RE: 447 Warburton Ave

Please see attached revised drawings for the above reference address. The changes include the following:

PROPOSED ALTERATION/ ADDITION

AT: 447 WARBURTON AVE. HASTINGS-ON-HUDSON, NY

A-3

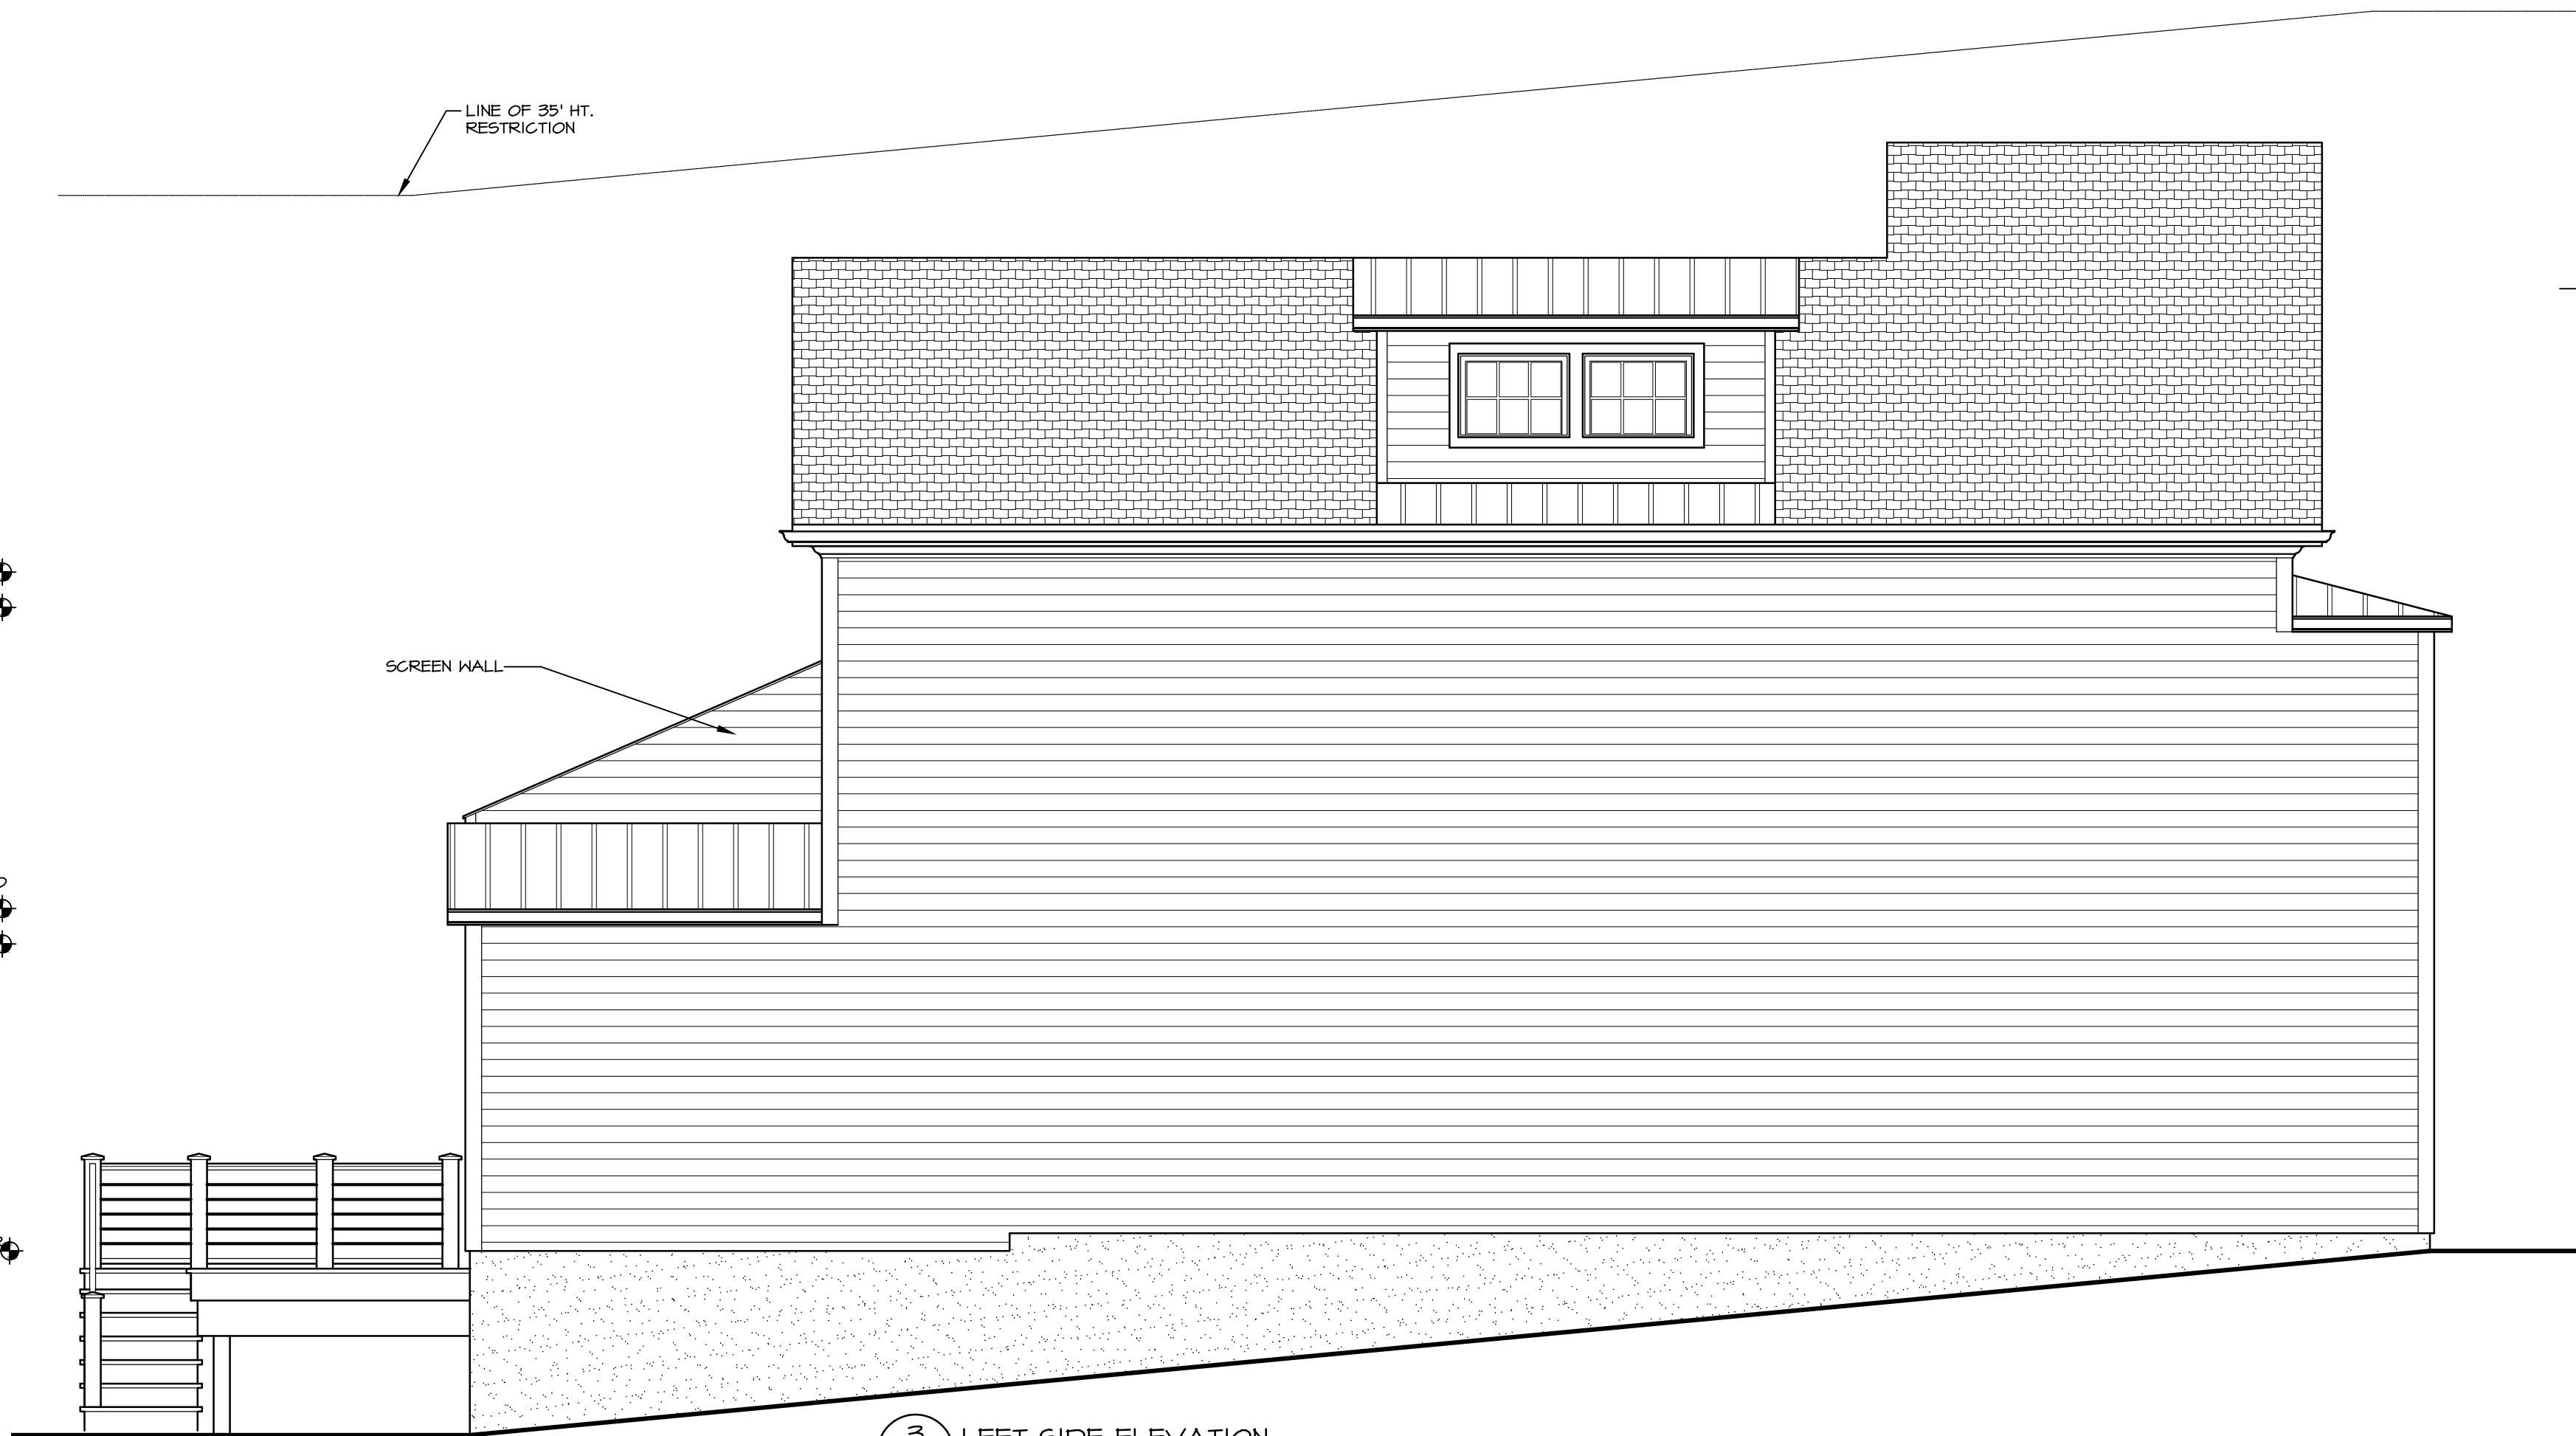
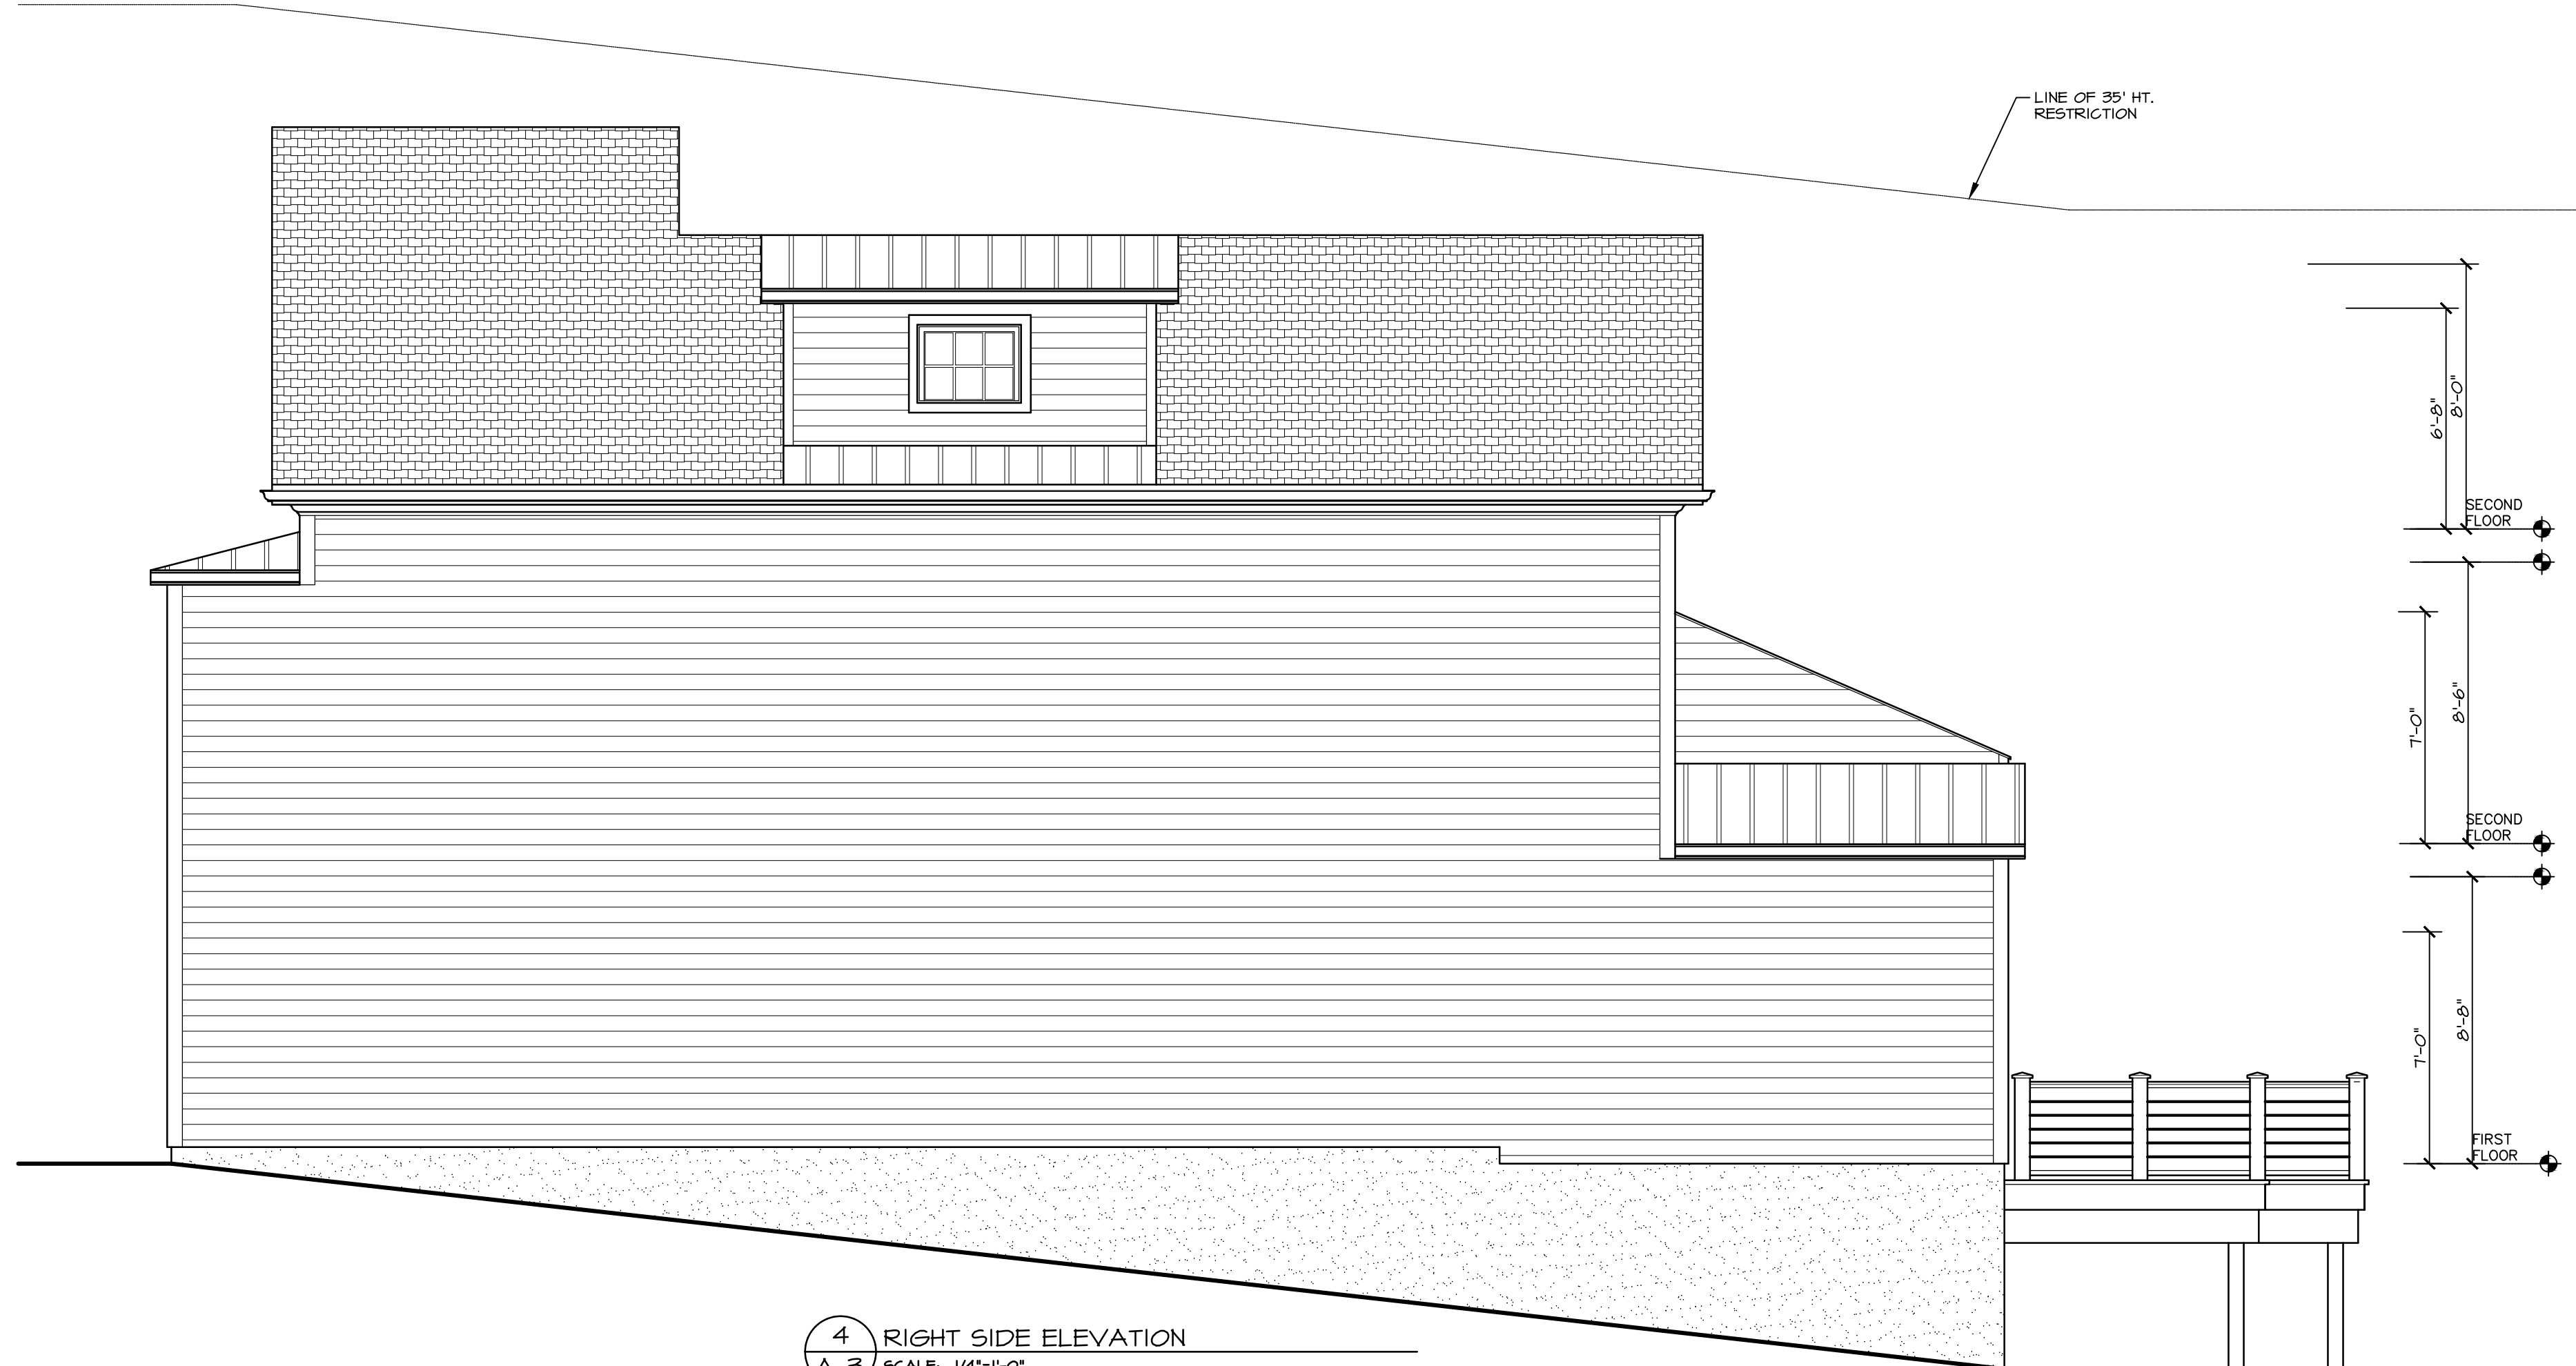
- 1.) The zoning chart has been revised because the deck now complies with the setback
- 2.) We have changed the size of the sliding doors at the rear of the dwelling on the first, second and third floor.
- 3.) The second-floor deck has been reduced and screen walls have been added.
- 4.) The third-floor front wall 4' back from the front setback.
- 5.) Third-floor knee wall has been reduced from 3'-0" to 1'-6"
- 6.) All elevations have been revised
- 7.) Dimensions have been added to ZA-5 sheet.
- 8.) Renderings have been revised and additional angles have been provided.
- 9.) Renderings from neighbor's residence have been added.
